# SERVICE BULLETIN

NON-MODIFICATION SERVICE BULLETIN — ENGINE — CASE, DIFFUSER, ASSEMBLY—  
REPLACEMENT OF SUSPECT DIFFUSER CASE ASSEMBLIES

V2500 Series 72-0707

72-42-11

LOCATION OF CASE ASSEMBLY  
FIGURE 1

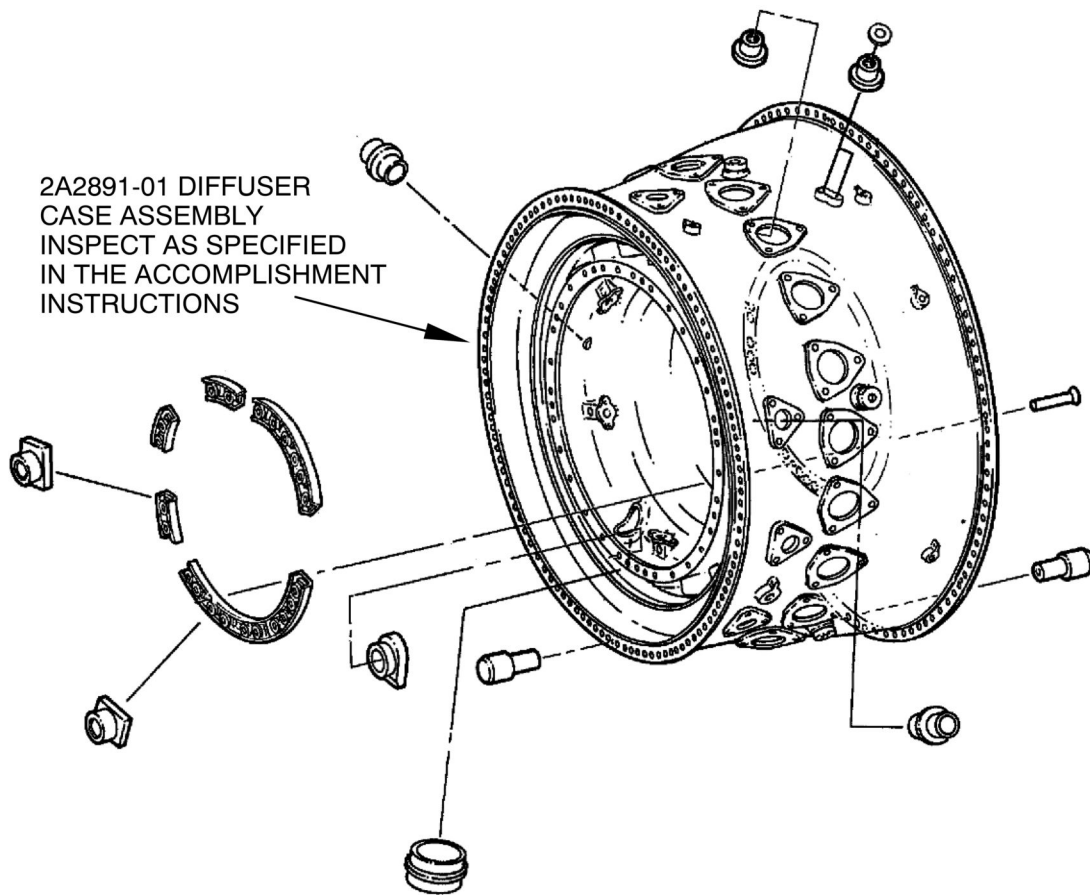
1. Inspect the Diffuser Case Assembly, PN 2A2891-01 for serial number listed in Table 1. See Figure 1.
  - A. For engines that do not have a diffuser case assembly with serial number listed in Table 1.

- (e) Remove the suspect diffuser case assembly as specified in Reference 3, Engine Manual, Chapter/Section 72-00-42.
    - (2) Replace suspect diffuser case:

- (a) Replace the suspect case assembly with a case that doesn't have a serial number listed in Table 1.
      - (b) The Diffuser Case Assembly, PN 2A2891-01 identified by serial number in Table 1 must be either returned to IAE or scrapped locally. If scrapped, a photograph or digital image of the mutilated diffuser case, and a copy of the scrap tag, countersigned by the local IAE Representative, must be provided to IAE Warranty.
